Interactive comment on “Emergent stationarity in Yellow River sediment transport and the underlying shift of dominance: from streamflow to vegetation” by Sheng Ye et al.

Please check the supplementary file for our complete response to reviewer 2. Anonymous Referee #2

Received and published: 29 October 2018

Fig. 1. Figure 2R1: Scatter plots between the maximum NDVI and slope in the Q-C regression (α_{QC}).

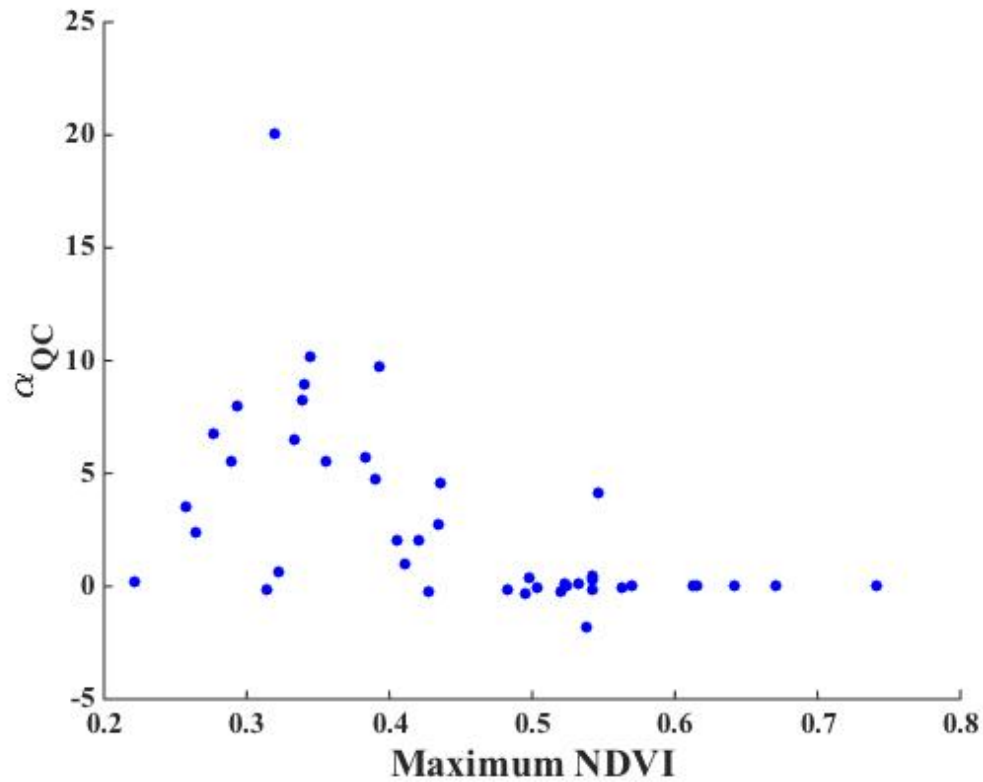
(1) "The sediment concentration follows a bell shape with NDVI at annual scale" was summarized throughout the text (e.g., Line 12/193/253), while the log-transformation was used to sediment concentration data in Figures 2 and 3. As we know, the log transformation is non-linear, thus the bell shape in Figures 2 and 3 may depend on this transformation approach.

We agree with the reviewer that log-transformation would change the shape of the correlation between NDVI and concentration. But as we shown here the increase and decrease trend of the bell shape sustains and is clear in linear scale. As the concentration covers a large range from 0.1kg/m³ to 700kg/m³, the points with small concentration (i.e. ≤ 100 kg/m³) would all collapse. The differences among these points cannot be shown clearly in linear scale. Thus, to make the relationship clearer we choose the log-transformation for better presentation. We hope the reviewer finds our explanation satisfactory.

Fig. 3. Figure 3R2: Scatter plot of annual mean concentration and maximum NDVI: (a) at 44 study gauges between 1982 and 1986, where the dots are color-coded by the slope in the Q-C regression ($\log_{10} \alpha_{QC}$) at each gauge

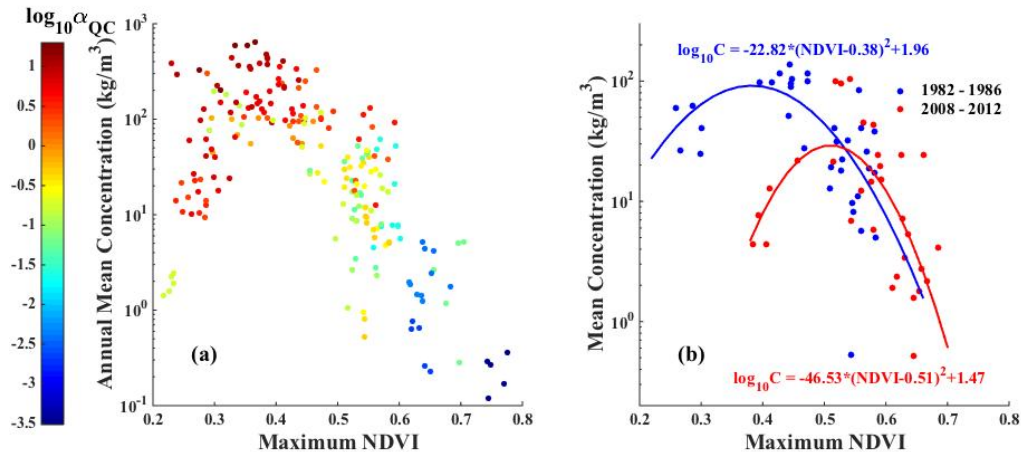
(2) In Figure 3, the authors should give the mathematical expression of the fitted curve with bell shape. Is it of a polynomial form or something else? Moreover, the goodness of the fit is expected to be presented.

Yes, it is a polynomial form. We have now shown the mathematical expression of the fitted curve, as well as the goodness of the fit in the figure. Thank you for your suggestion (please see the updated Figure 3).

Fig. 4. Figure R1: Scatter plot of annual mean concentration and dominant soil types: the denotations are as follows: 1: hilly gully region 1; 2: hilly gully region 2; 3: hilly gully region 3; 4: hilly gully

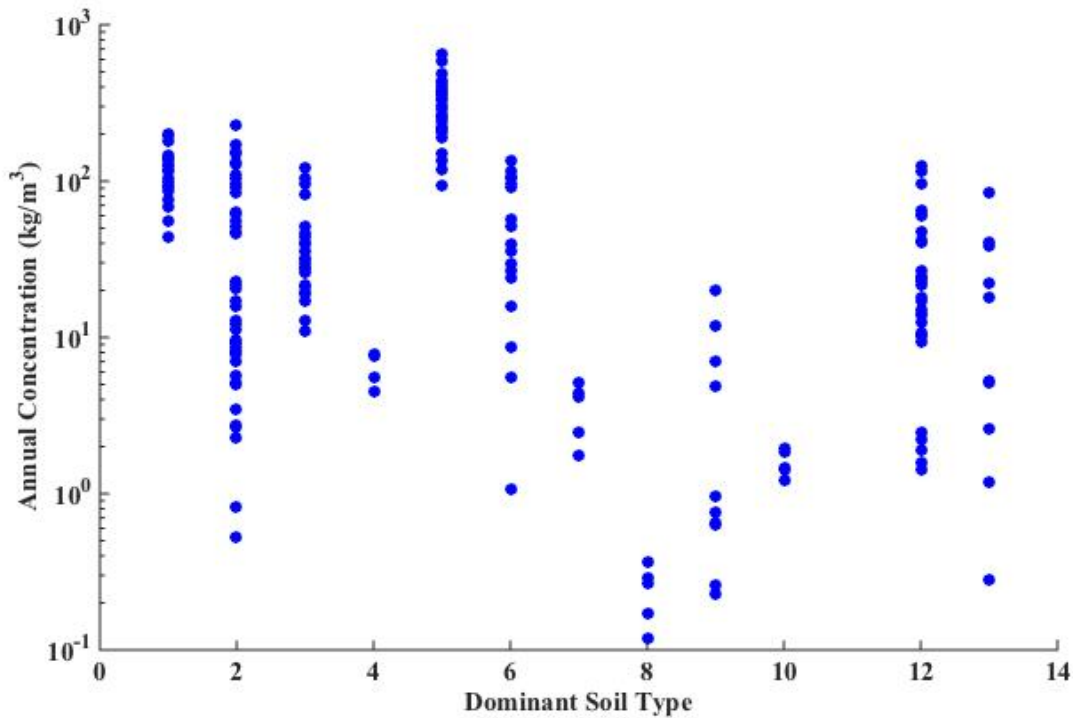
(3) It's doubtful that the so-called emergent stationarity is attributed only to vegetation resistance. The physical connection between vegetation condition and sediment concentration is not as explicit as that between discharge and sediment concentration. In addition, the discharge and the vegetation were separately incorporated to consider the impact to sediment condition. So, the conclusion in this study is under very strong assumption, i.e., the sediment condition in a basin is only controlled by discharge and vegetation. However, this assumption was not listed clearly. On the other hand, was it reasonable? In addition to vegetation, resistance of sediment to erosion may be related to other property of the basin, such as soil properties. Authors said sediment concentration follows a bell shape with vegetation index. I guess that the mean sediment concentration also follows a bell shape with the mean runoff. According to literatures, the discharge of 1982-1986 in many sub-basins of Yellow River was much larger than that in 2008-2012, how to compare the decreased discharge contribution with the in-

We have also studied the correlation between dominant soil types and sediment concentration, the plot is quite scatter, thus we didn't show it in the manuscript for brevity. The results is shown in Figure R1. It is possible that there are other factors we didn't consider here that influences the sediment transport, however, given the good fit between maximum NDVI and concentration, it is reasonable to say that vegetation plays an significant role in the soil erosion and sediment transport in the YRB, though it may not be the only controlling factor.

Fig. 5. Figure 3R3: Scatter plot of annual mean concentration and annual discharge: (a) at 44 gauges between 1982 and 1986, where the dots are color-coded by the slope in the Q-C regression ($\log_{10} \alpha_{QC}$) at each

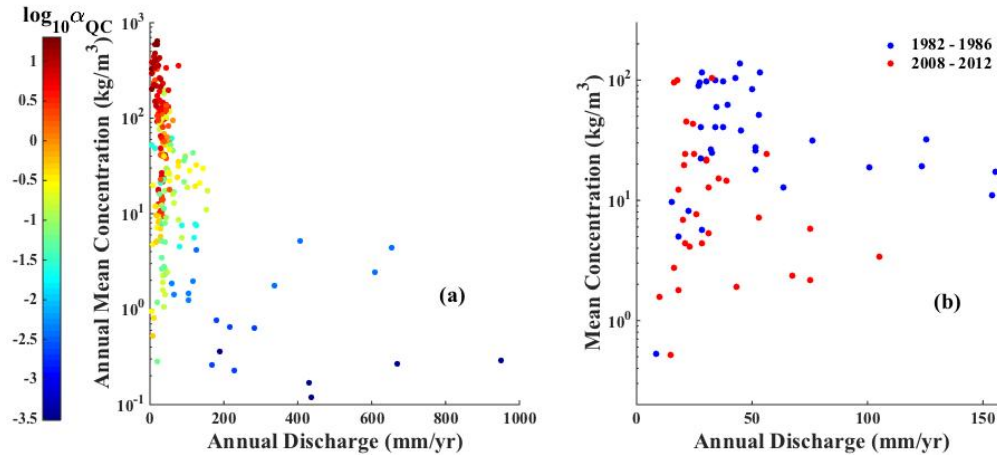
creased NDVI contribution to the concentration? Can the authors add the plot of mean sediment concentration against annual discharge with the same period and gauges in both Figure 3a and 3b?

The relationship between annual discharge and concentration is shown in Figure 3R3. As we can see from Figure 3R3a, instead of a bell shape correlation, the mean concentration generally declines with annual discharge for all the 68 study gauges. However, this trend doesn't sustain for the seven gauges at the outlet of major tributaries (Figure 3R3b), where the plot is more scatter. This is consistent with our findings in Figure 1b, that these gauges near the outlet of tributaries have less coupled discharge-concentration relationship. Although the discharge of 1982 – 1986 is smaller than that in 2008 – 2012, we believe the strength of the correlation between Q-C would sustain. Moreover, from Figure 1b, we can see that usually catchments with smaller discharge have stronger Q-C correlation. As we can from Figure 3R3b, the plots are scatter in both 1982 – 1986 and 2008 – 2012 despite of the change in discharge. Thus, we think that the vegetation is a better indicator of concentration than discharge.

Fig. 6. Figure 3R4: Scatter plot of annual mean concentration and mean NDVI: (a) at 44 study gauges between 1982 and 1986, where the dots are color-coded by the slope in the Q-C regression (α_{QC}) at each gauge

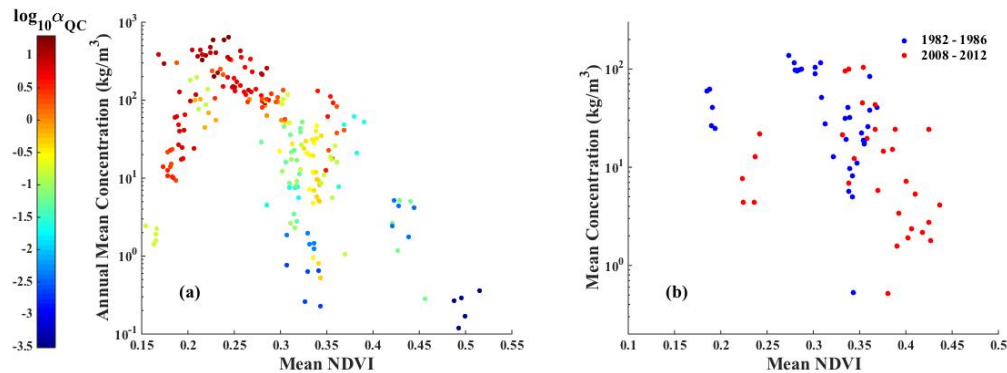
(5) Why not use the mean NDVI, but the maximum (daily?) NDVI, when you investigated the relationship between the NDVI and mean concentration at annual scale? How much uncertainty for the maximum NDVI exists?

We tried the mean NDVI as well, the rising and falling trend is still apparent (see following figure), but the maximum NDVI provides better shape. Thus, we chose to use the maximum NDVI for presentation. One possible reason is that the vegetation types in the YRB are mostly deciduous, the green period is relatively short, an averaged NDVI could decrease the difference among vegetation density. Since the variability in maximum NDVI for each site is not very large (Figure 3a), and the trend is consistent between mean NDVI and maximum NDVI, we think the uncertainty for the maximum NDVI is not significant for this study. We hope the reviewer finds our explanation sufficient.

Fig. 7. Figure S1: Spatial distribution of hydrology gauges used in this study. The green triangles correspond to 68 gauges with discharge and sediment concentration data, the red circles correspond to 44 sel

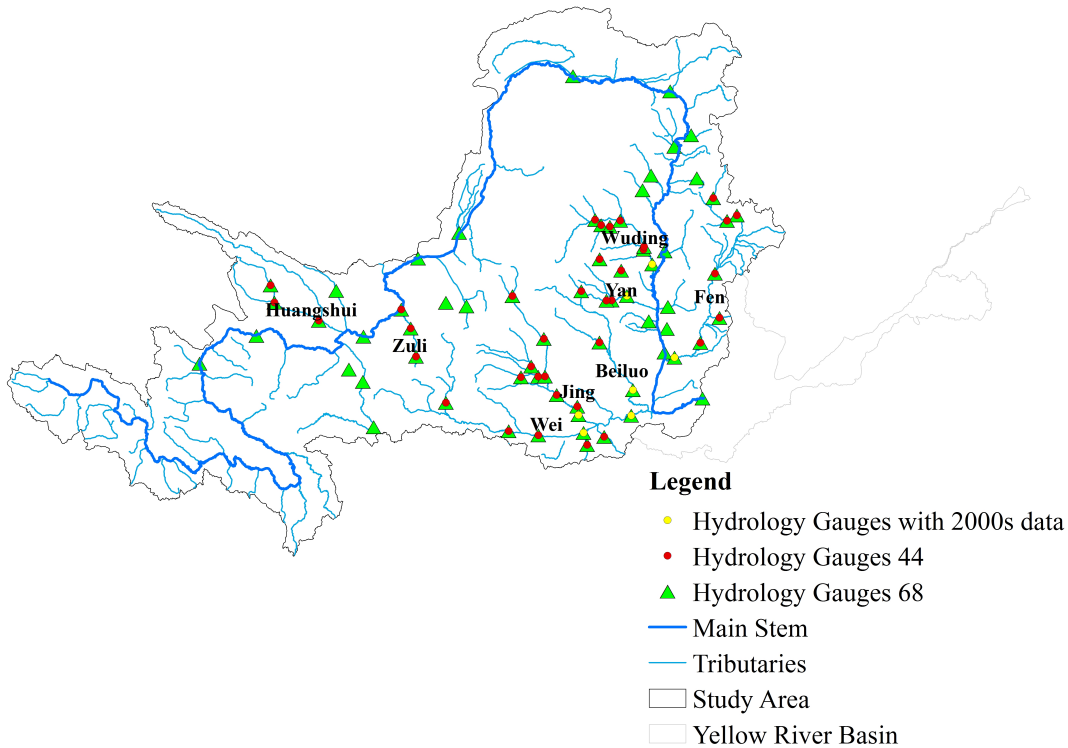
(6) In Figure A1, the text in legend is inappropriate, because there were not 68 green triangles plotted (maybe $68-44=22$ gauges).

Since the 44 gauges belongs to the 68 gauges, it might be confusing to use 22, we have changed the symbol to make it clear. Hopefully the reviewer finds the updated figure appropriate.

Fig. 8. Figure 1: Scatter plots between long-term mean annual discharge (Q_m) and (a) wavelet Q-C coherence at daily, monthly and annual scales, (b) slope of the discharge- sediment concentration regression (α_{QC})

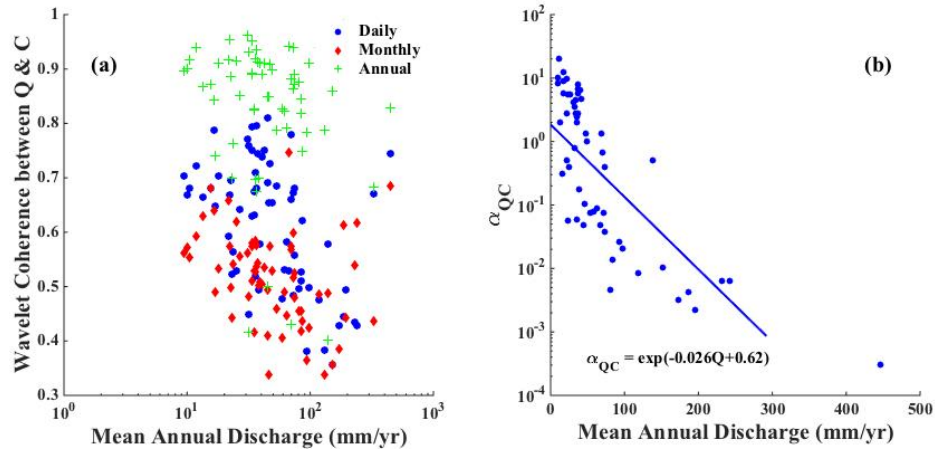
(7) On line 120, “annual scale . . . is when the coupling from wavelet coherence analysis is strongest”, why?

(8) On line 141-142, “slope in the Q-C regression (aQC) declines exponentially with Q_m (p-value < 0.0001)”. From the Figure 1b, it looks like log-transformation used to aQC. If so, then the text expression and plot were inconsistent. And the authors should give the mathematical equation of exponential decline trend and its fitted curve.

As we can see from Figure 1a and A3, the annual scale has largest wavelet coherence. The wavelet coherence is like the correlation coefficient, the larger it is, the more correlated the two variables are. Thus, we chose to use the annual for further analysis. We have made the following changes in the manuscript, we hope the reviewer finds our explanation sufficient (please see lines 133 – 135).

Thank you for noticing the logarithmic scale in y axis. We chose to use logarithmic scale for the slope in Q-C regression to better present the differences among small values which is a large amount in the study catchment, otherwise the small values would just cluster together. Taking the log-transformation on both side of the exponential regression, we will have a linear relationship between $\log(aQC)$ and Q . We have added the fitted curve and the equation in the updated Figure 1. We are sorry about the confusion and hope the reviewer will find our explanation satisfactory. Thank you!
